**ADDENDUM
NO. 3**

November 6, 2023

**HANOVER COMMUNITY SCHOOLS - JANE BALL ELEMENTARY
RENOVATIONS AND HIGH SCHOOL IMPROVEMENTS**

Addendum Two (AD.03) to the drawings and specifications prepared by Gibraltar Design for **Hanover CSC – Jane Ball ES Renovation and HS Improvements** for Hanover Community School Corporation, Cedar Lake, Indiana.

DRAWING
HIGH SCHOOL LIFE SAFETY PLAN

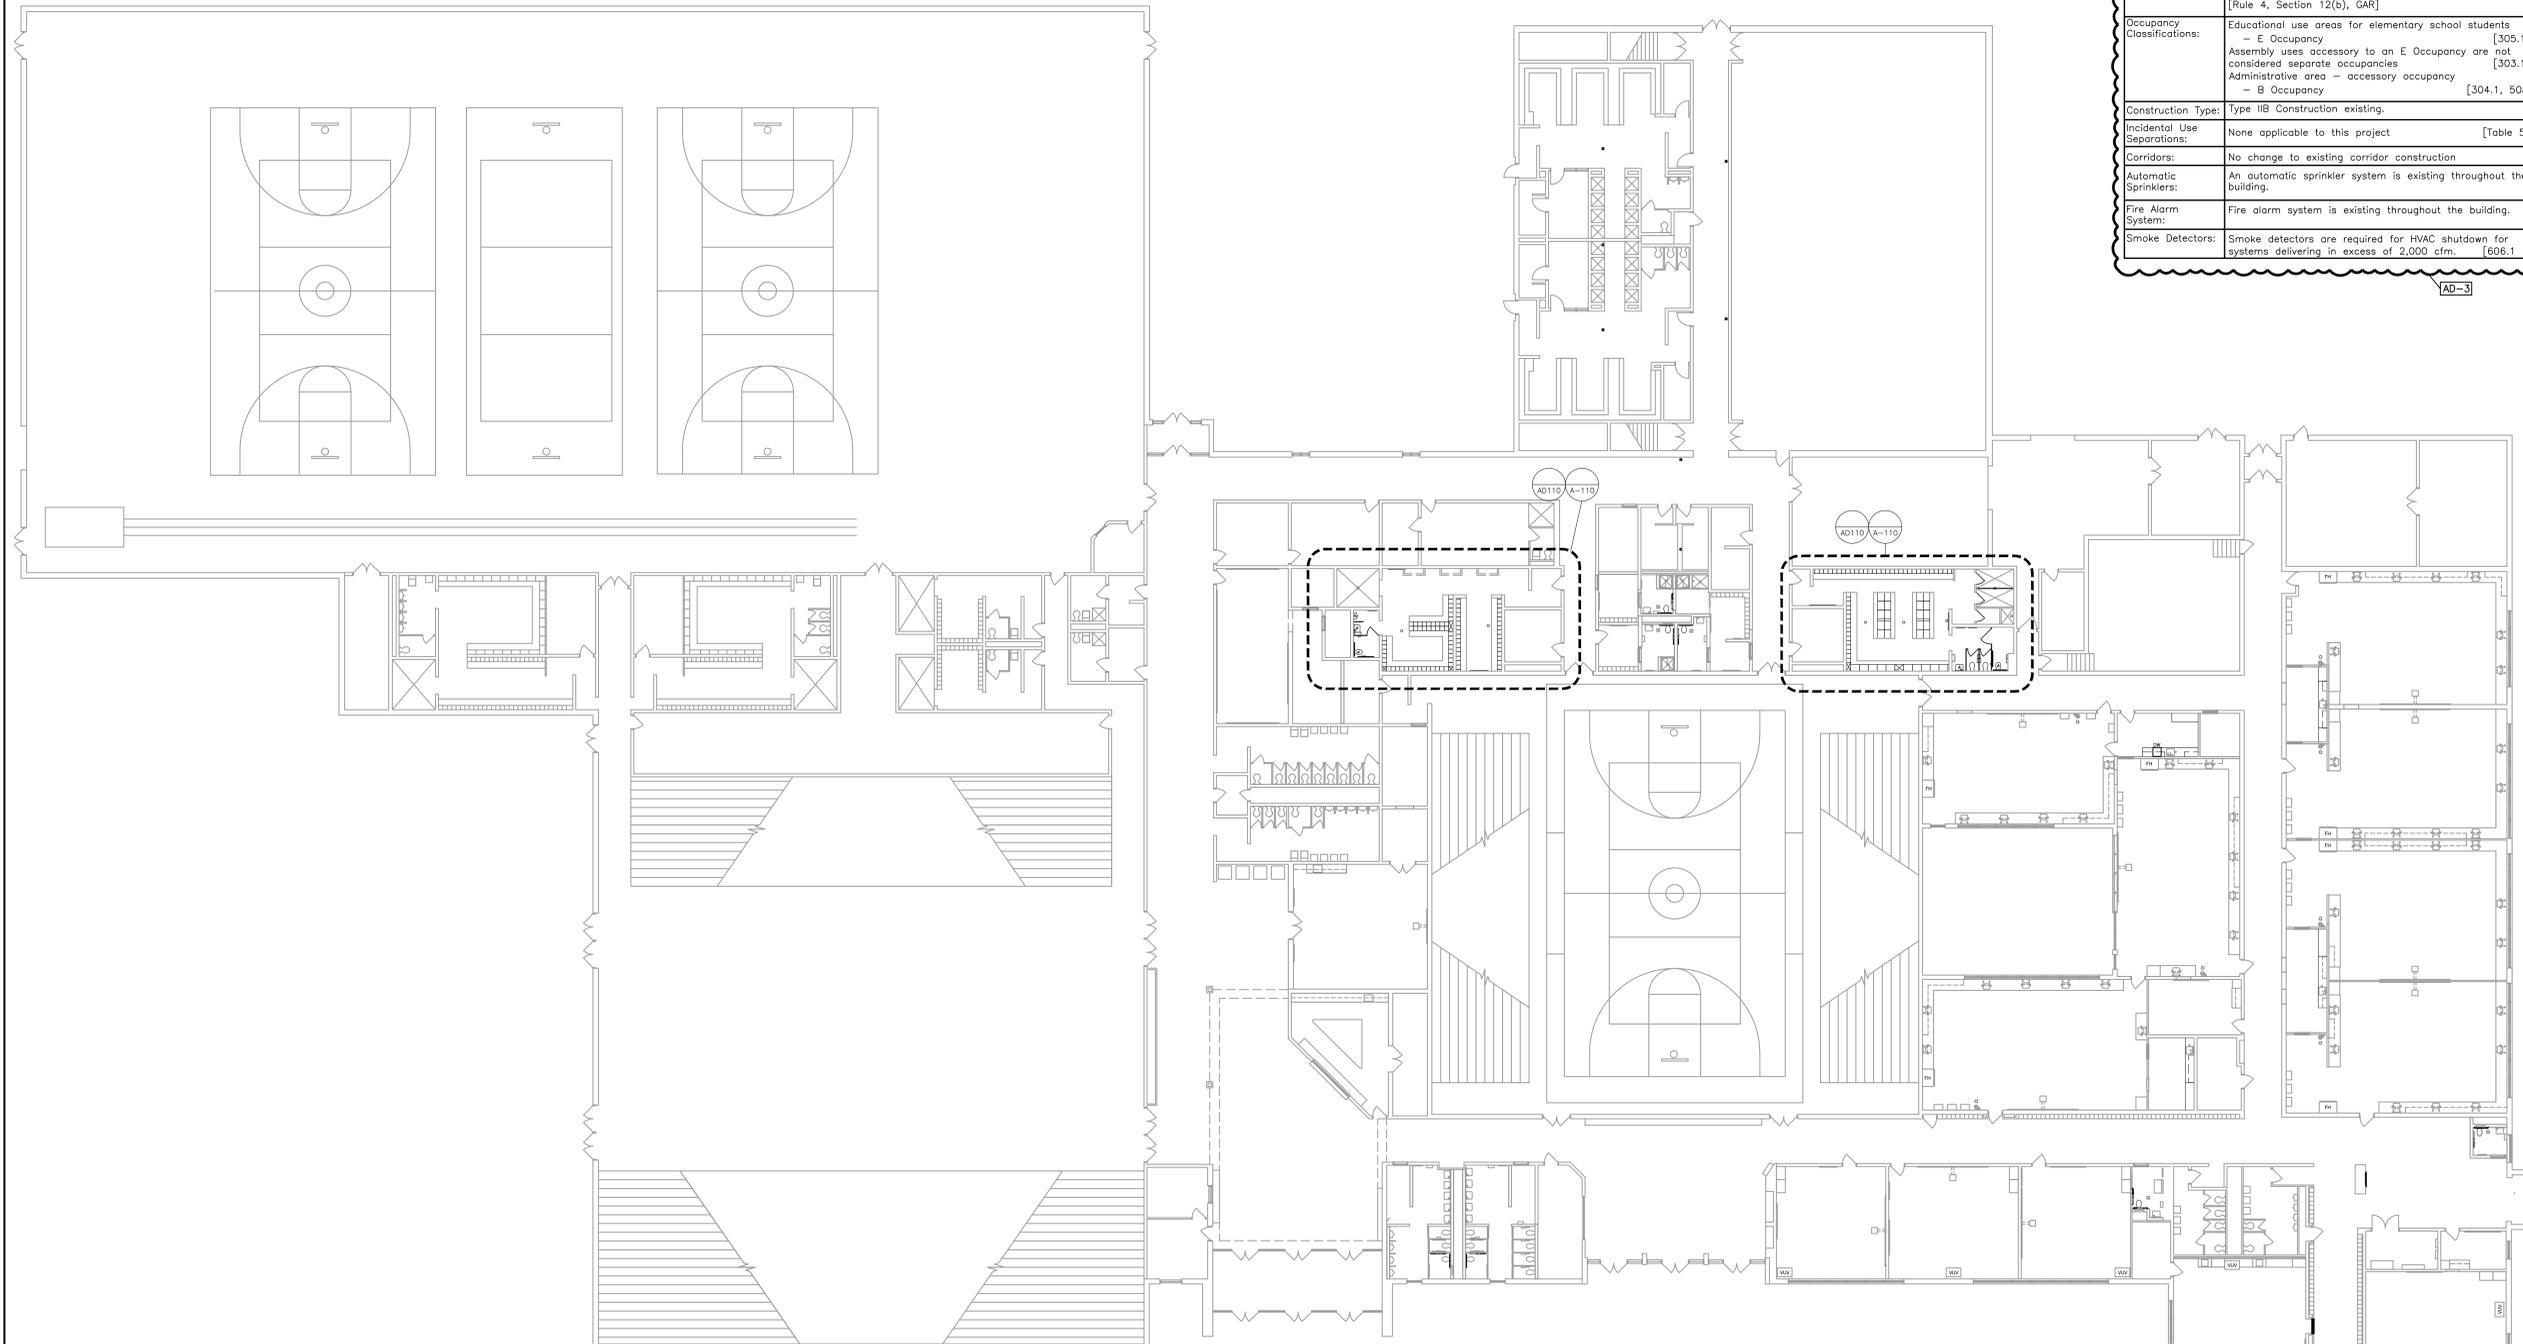
2. Sheet G-201 & G-202

- A. Refer to revised full-size drawing, included in this Addendum for the addition of the Code Summary.

GIBRALTAR DESIGN SHEET
C-3.0

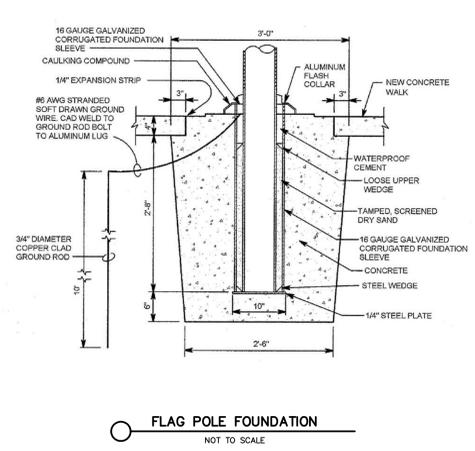
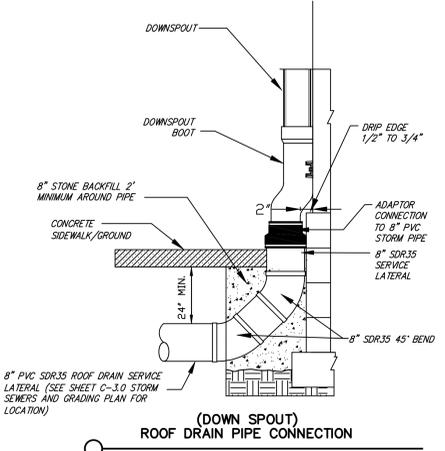
5. Sheet C-3.0

- A. Refer to revised full-size drawing, included in this Addendum for the addition of proposed elevations for the new sidewalk.

GIBRALTAR DESIGN SHEET
JB S-102

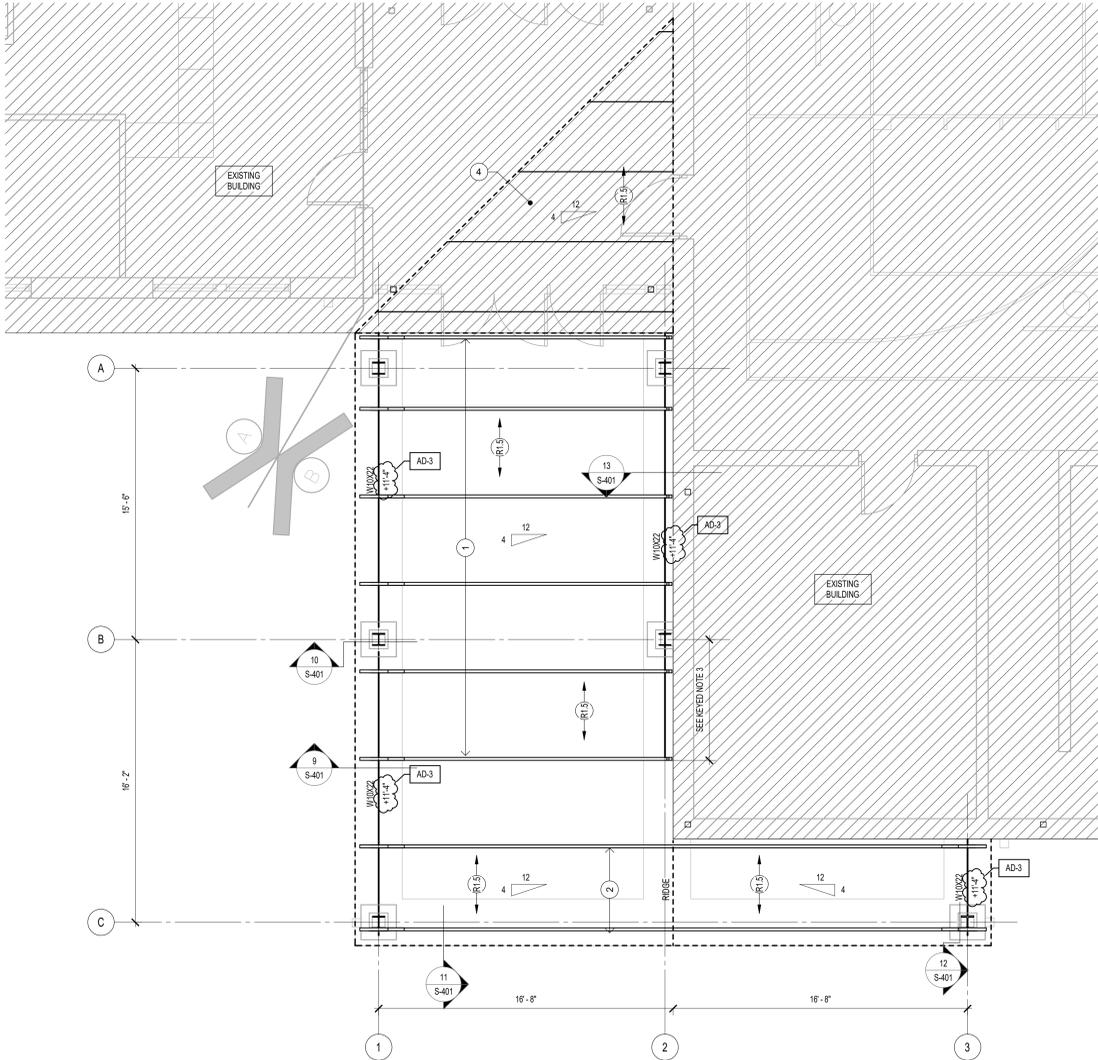
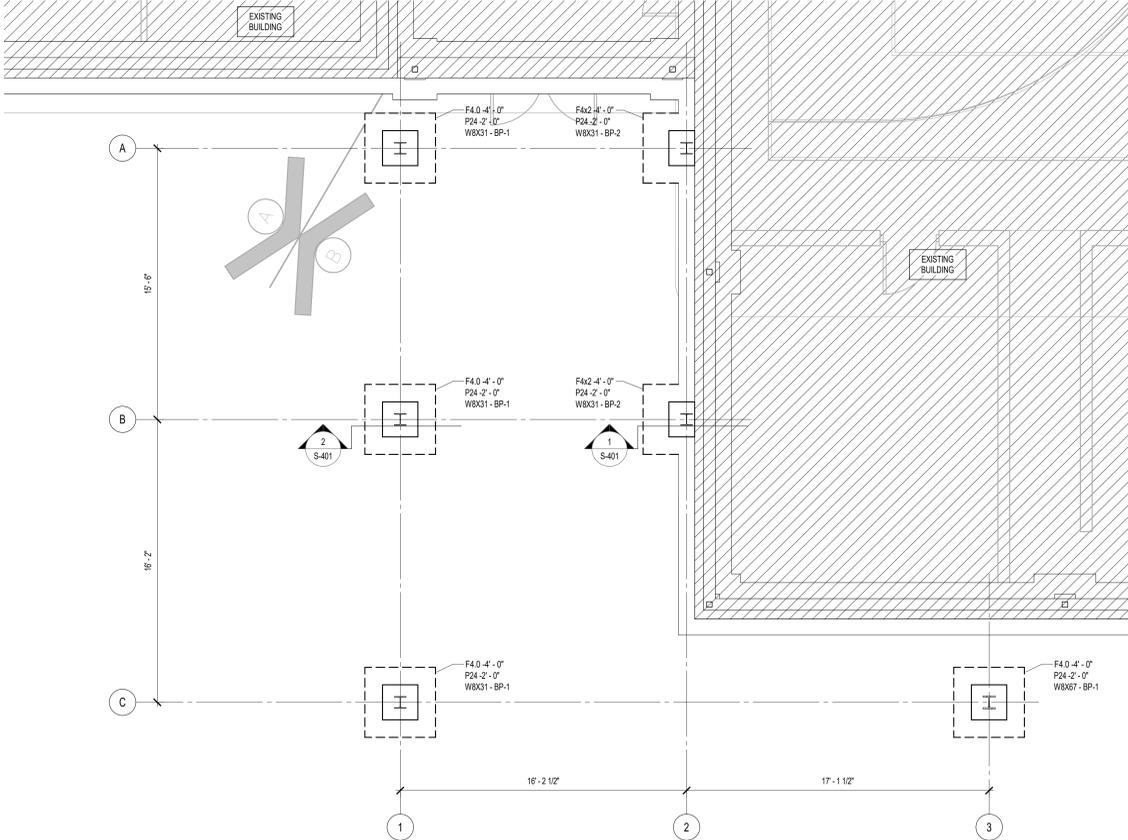
10. Sheet S-102

- A. Refer to revised full-size drawing, included in this Addendum for the following revisions.
 - 1. Sheet number revised (originally S-101).
 - 2. The top of steel elevation for new beams adjusted.
 - 3. Foundation plan note revised as shown.
 - 4. Keynote 4 was added to the framing plan.

14 NEW LINTEL IN EXISTING WALL
3/4" = 1'-0"

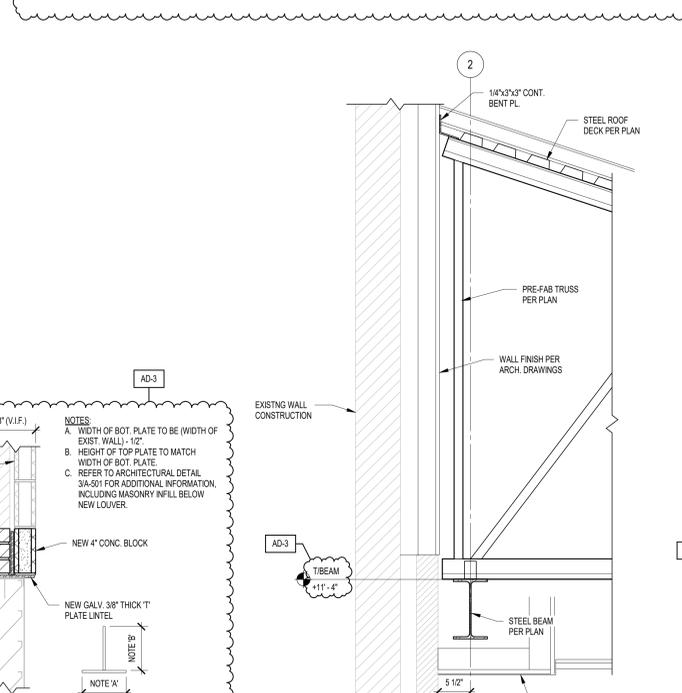
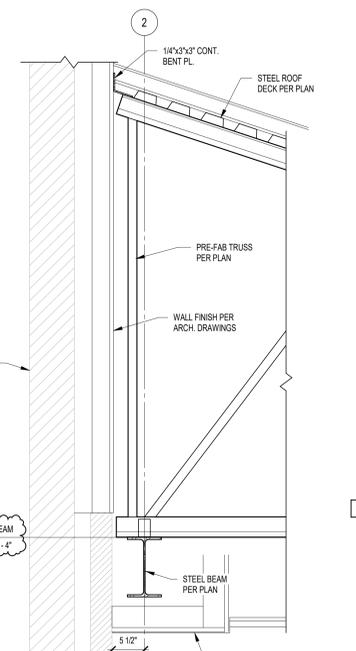
12. Sheet S-401

- A. Refer to revised full-size drawing, included in this Addendum for the following revisions.
 - 1. Block changed to 8" on sections 1 and 2.
 - 2. The top of steel elevation adjusted on details 9 and 13.
 - 3. Truss heel height noted to be field verified in order to match existing conditions on section 13.
 - 4. New details 14 and 15 added.

PROJECT: HANOVER CSC - JANE BALL ES RENOVATIONS AND HS IMPROVEMENTS
DRAWING: HIGH SCHOOL LOCKER ROOM ARCHITECTURAL DEMOLITION PLAN
SHEET: HS AD110

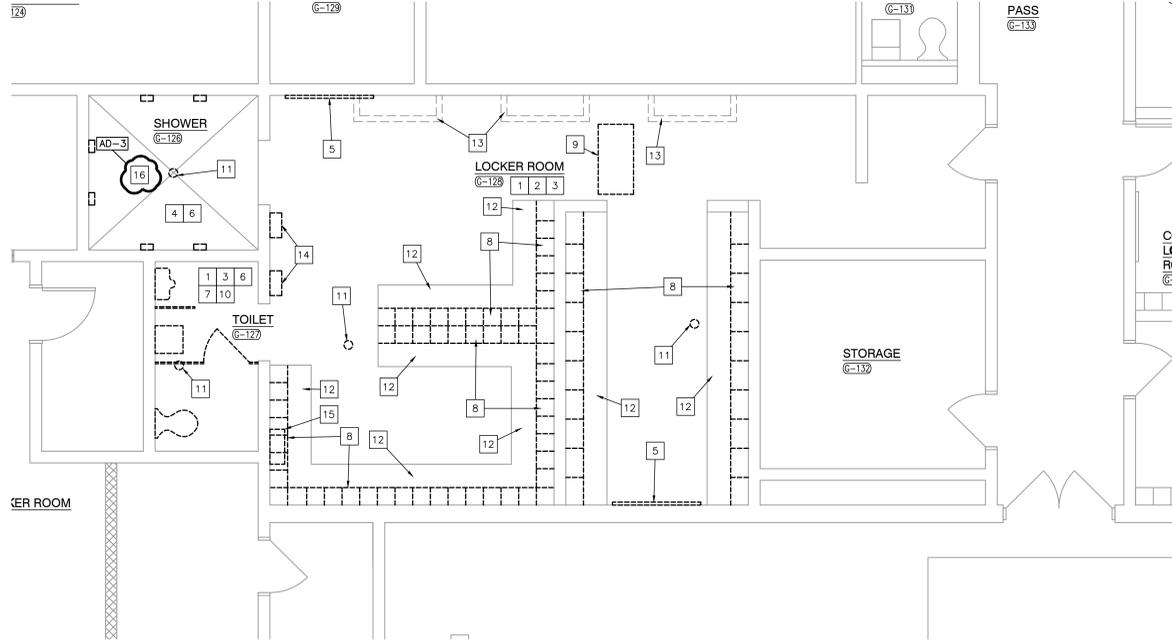
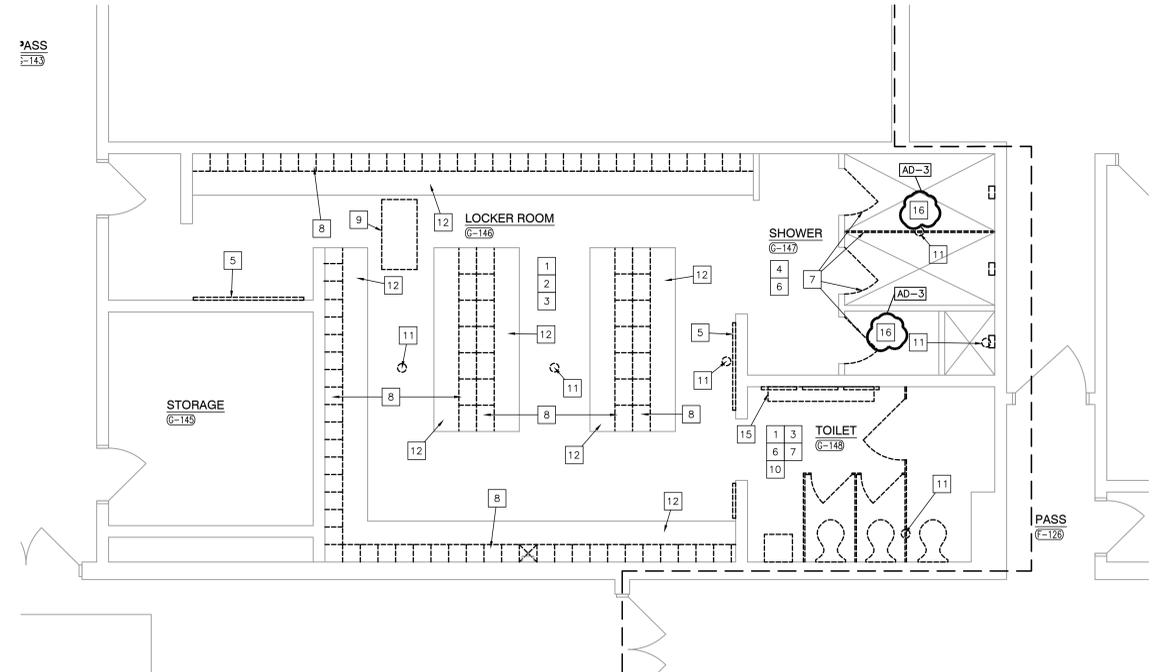
13. Sheet AD-110

- 1. Refer to revised full-size drawing, included in this Addendum for the addition of note 16 in the showers in both locker rooms.
